KCCD Building and Tenant Improvements Project

ADDENDUM NO. 2
Issued: January 18, 2021

You are hereby notified of the following changes, deletions, additions, corrections and clarifications to the plans, specifications and other documents comprising the Contract Documents for the Kittitas County Conservation District’s KCCD Building Improvements Project issued for bid January 4, 2021.

Existing Floor Plan

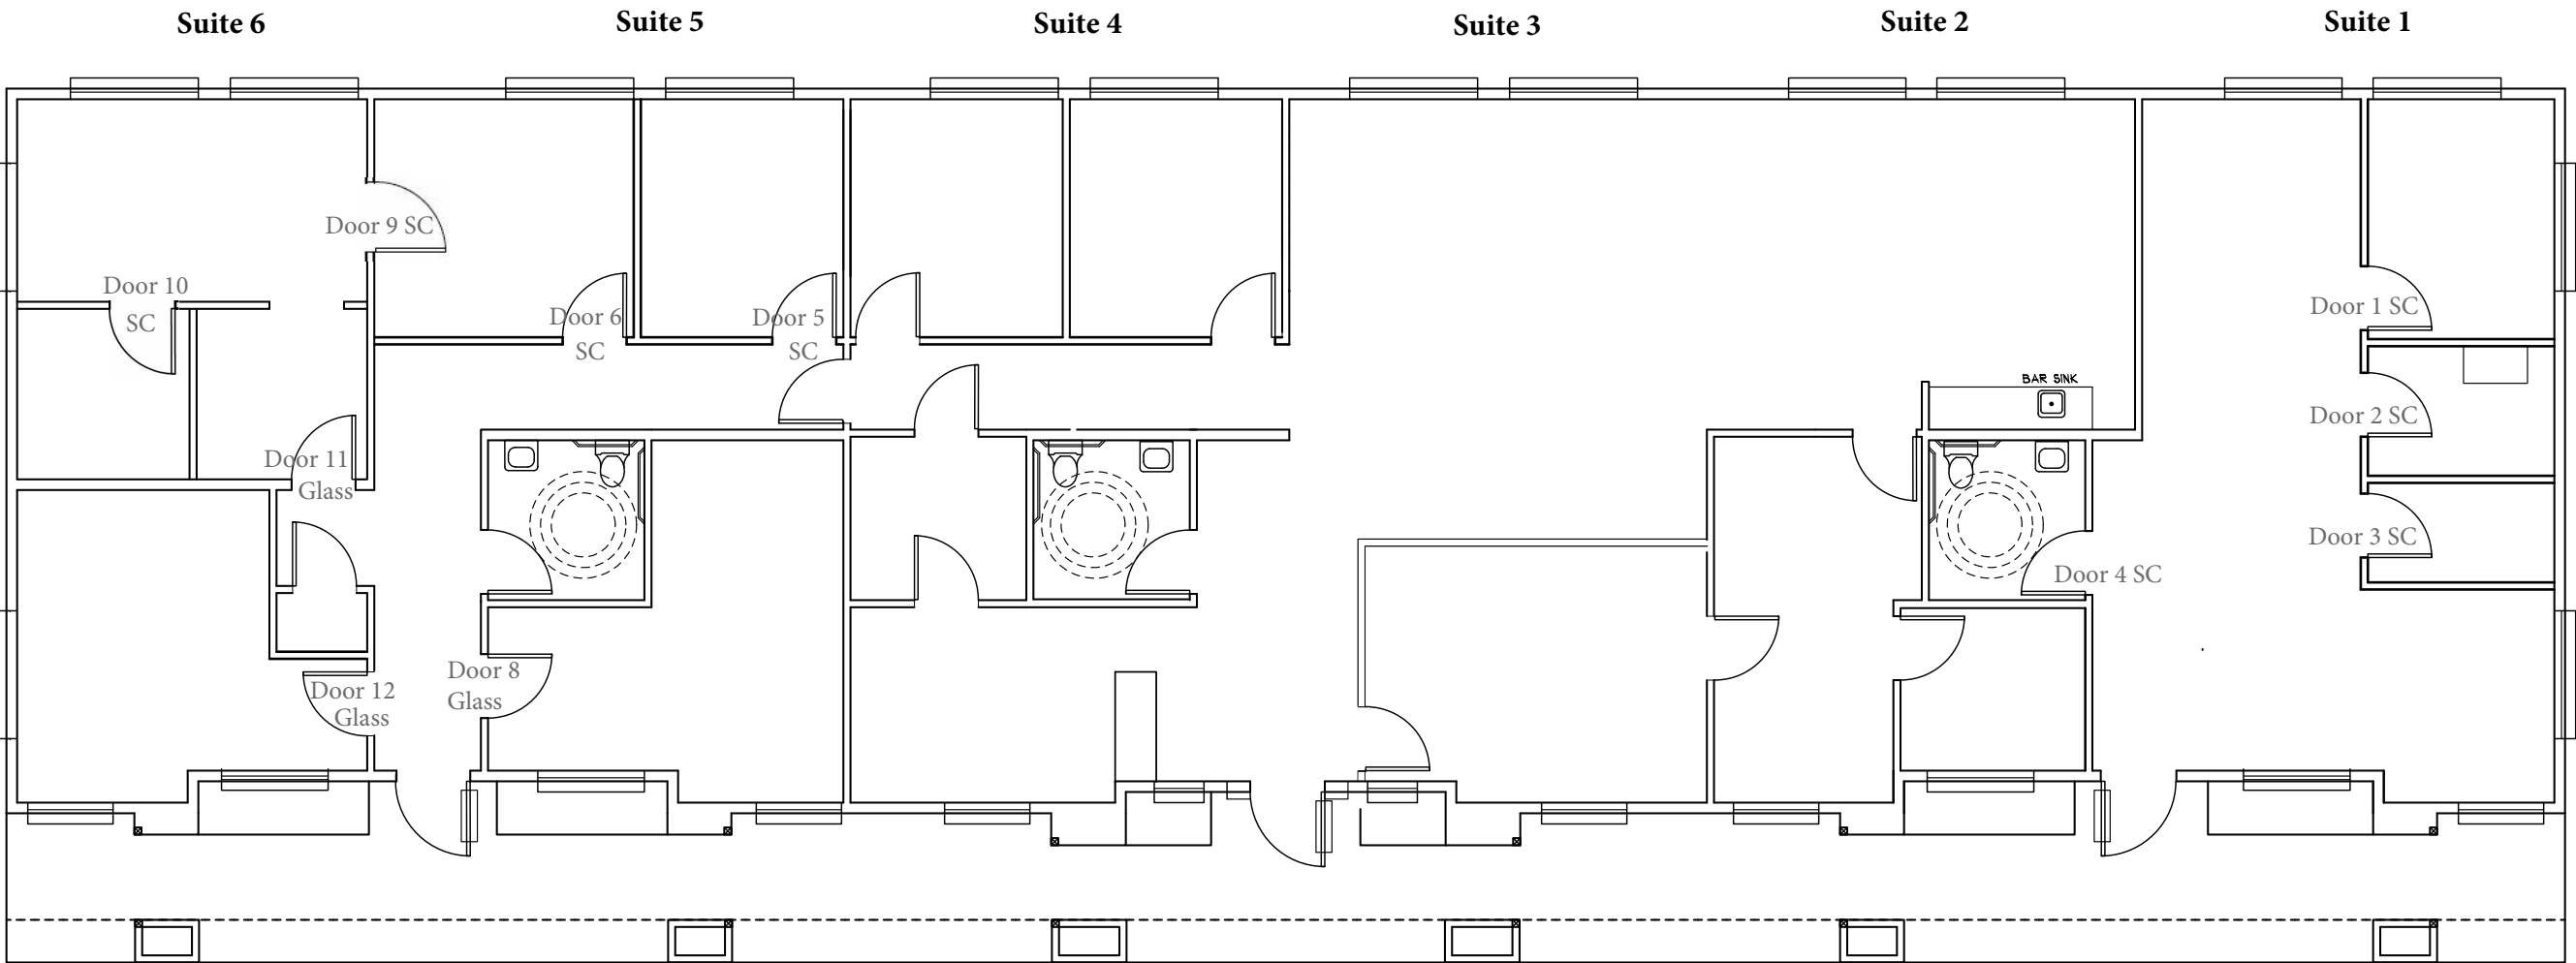
- 3) **Plans** – Plan sheets for existing conditions and the modifications have been amended to include additional information about existing doors and new door placements as well as indicating the correct number of light fixtures in Suite 1. Also note that the door to NRCS private office should swing in, not out as previously drawn.

Door Inventory below includes only doors that will be modified as part of the tenant improvements. SC indicates solid core doors. Glass indicates full glass panel doors

MAIN FLOOR PLAN

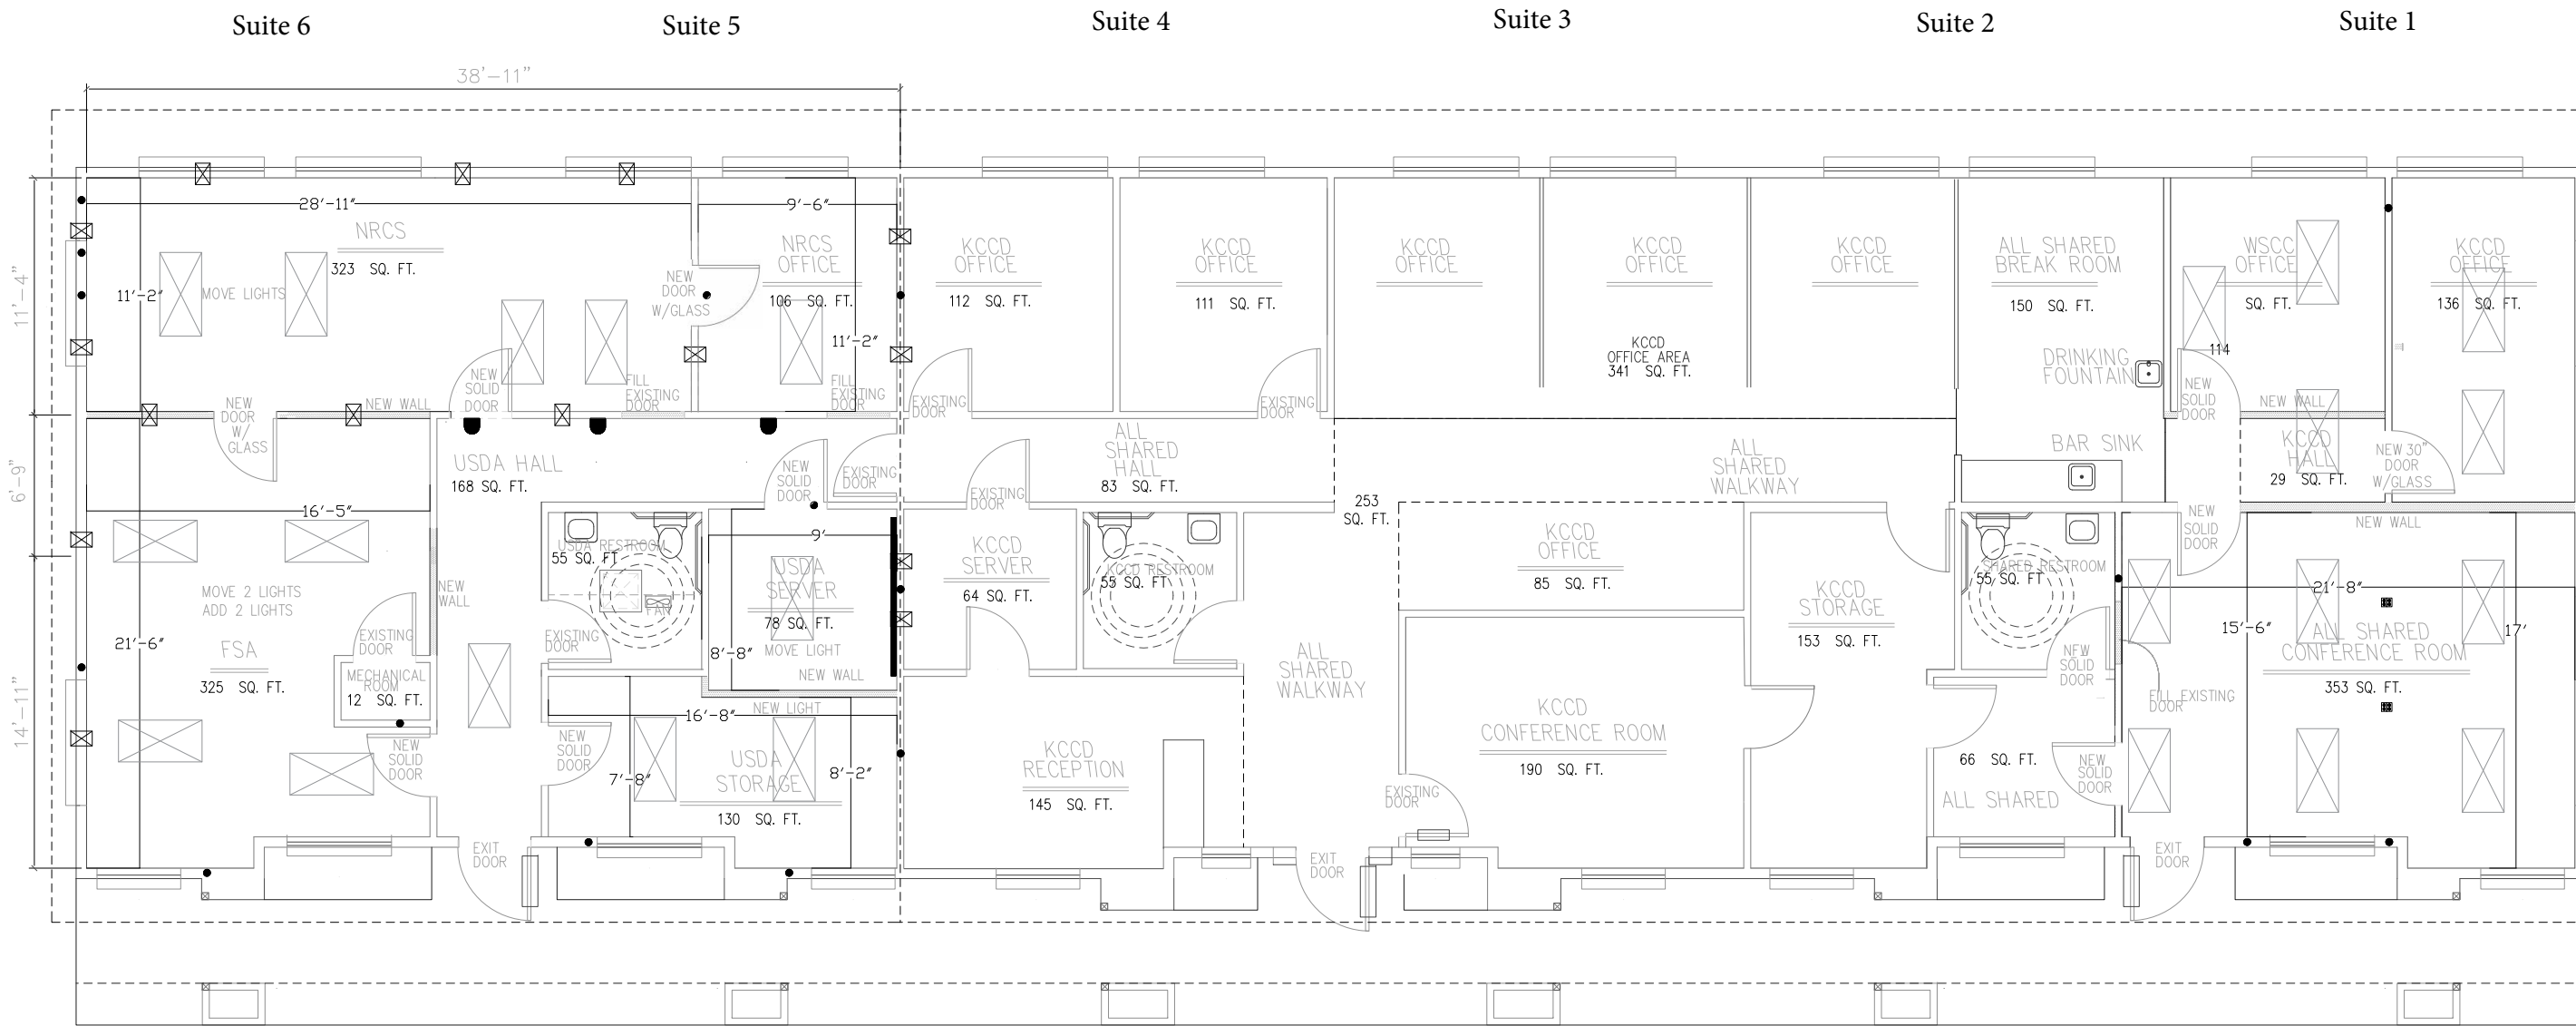
- a. Yes, one (1) additional fixture is needed in the USDA storage room (Suite 5) and two (2) additional fixtures are needed in the Suite 6. Existing fixtures should be relocated as indicated on the plan sheet.
